Access Compliance Report

Public Rights-of-Way

(Curb Ramps)

Intersection ID: 10035372	Main Street: RAMA_RD	Cross Street: N/A	Location: E
ADA ID: 48F185392935	Ramp Type: Perp	Initial Pass/Fail: Fail	Overall Compliance: No
			Severity Score: 21.25

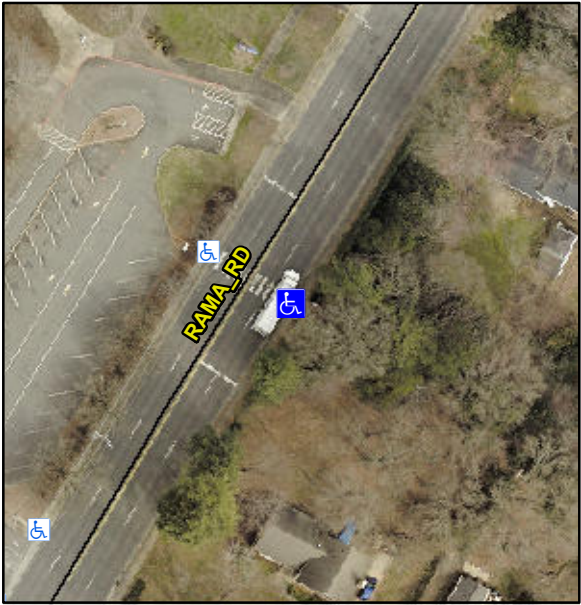
Codes/Mitigation Info/Possible Solution			Field Measurements/Component Compliance			
	Possible Solutions:		Compliance	Description	Data	Compliance
	Remove & Replace Entire Ramp.		No	Ramp Length (in)	64.0	No
			No	Ramp Width (in)	40.0	Yes
			N/A	Flare Type LT	N/A	N/A
			N/A	Flare Slope LT (%)	N/A	N/A
			N/A	Flare Traversable LT?	N/A	N/A
			N/A	Landing Length (in)	N/A	N/A
			N/A	Landing Width (in)	N/A	N/A
			N/A	Landing Slope (%)	N/A	N/A
			N/A	Landing X Slope (%)	N/A	N/A
<p>Surveyor Notes:</p> <p>N/A</p> <p>PROW/ADA:</p> <p>Not Found, R304.5.1, R304.2.2</p>			N/A	Flare Type RT	N/A	N/A
			N/A	Flare Slope RT (%)	N/A	N/A
			N/A	Flare Traversable RT?	N/A	N/A
			N/A	DWS Provided?	N/A	N/A
			N/A	DWS Contrast?	N/A	N/A
			N/A	DWS Length (in)	N/A	N/A
			N/A	DWS Full Width?	N/A	N/A
			N/A	DWS Offset (in)	N/A	N/A
			N/A	Gutter Ponding?	N/A	N/A
			N/A	Gutter Lip Ht (in)	N/A	N/A
<p>Total Cost:</p> <p>\$ 1850.00</p>			N/A	Painted X Walk1?	Yes	N/A

N/A	X Walk 1 Direction	To NW	N/A
			N/A	X Walk 1 Width (in)	123.0	N/A
			N/A	X Walk 1 Slope (%)	0.5	N/A
			N/A	X Walk 1 X Slope (%)	0.6	N/A
			N/A	Ramp inside XWalk1?	Yes	N/A
			N/A	Road Slope (%)	N/A	N/A
			N/A	Road X Slope (%)	N/A	N/A
			N/A	Any Obstructions?	N/A	N/A
			N/A	Obstruction Type		N/A
			N/A			N/A
			Yes	Surface Condition? (G/P)		Good
